Access Compliance Report

Public Rights-of-Way

Intersection ID: 48434	Main Street: ORANSAY_WY	Cross Street: WHITHORN_WY	Location: SE
ADA ID: 04837F512329	Ramp Type: PerpDiag	Initial Pass/Fail: Fail	Overall Compliance: No
		Severity Score: 8.75

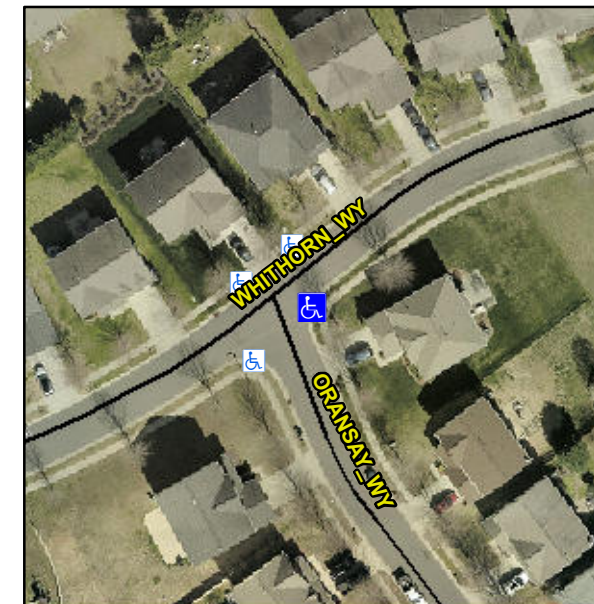
Not Found, R304.5.1

Compliance	Description	Data	Compliance	Description	Data
N/A	Ramp Length (in)	47.0	Yes	Ramp Slope (%)	5.5
No	Ramp Width (in)	47.0	Yes	Ramp XSlope (%)	1.7
N/A	Flare Type LT	N/A	N/A	Flare Type RT	N/A
N/A	Flare Slope LT (%)	N/A	N/A	Flare Slope RT (%)	N/A
N/A	Flare Traversable LT?	N/A	N/A	Flare Traversable RT?	N/A
N/A	Landing Length (in)	N/A	N/A	DWS Provided?	N/A
N/A	Landing Width (in)	N/A	N/A	DWS Contrast?	N/A
N/A	Landing Slope (%)	N/A	N/A	DWS Length (in)	N/A
N/A	Landing X Slope (%)	N/A	N/A	DWS Full Width?	N/A
N/A	Landing Curb? (Y/N)	N/A	N/A	DWS Offset (in)	N/A
N/A	Shared Landing?	N/A			
N/A	Gutter Ponding?	N/A	N/A	Gutter Slope (%)	N/A
N/A	Gutter Lip Ht (in)	N/A	N/A	Gutter X Slope (%)	N/A
N/A	Painted X Walk1?	No	N/A	Painted X Walk2?	No
	X Walk 1 Direction	To N		X Walk 2 Direction	To SW
N/A	X Walk 1 Width (in)	N/A	N/A	X Walk 2 Width (in)	N/A
	X Walk 1 Slope (%)	4.0		X Walk 2 Slope (%)	1.8
	X Walk 1 X Slope (%)	2.2		X Walk 2 X Slope (%)	2.0

Remove & Replace Curb Ramp With Two New Directional Ramps or Equivalent.
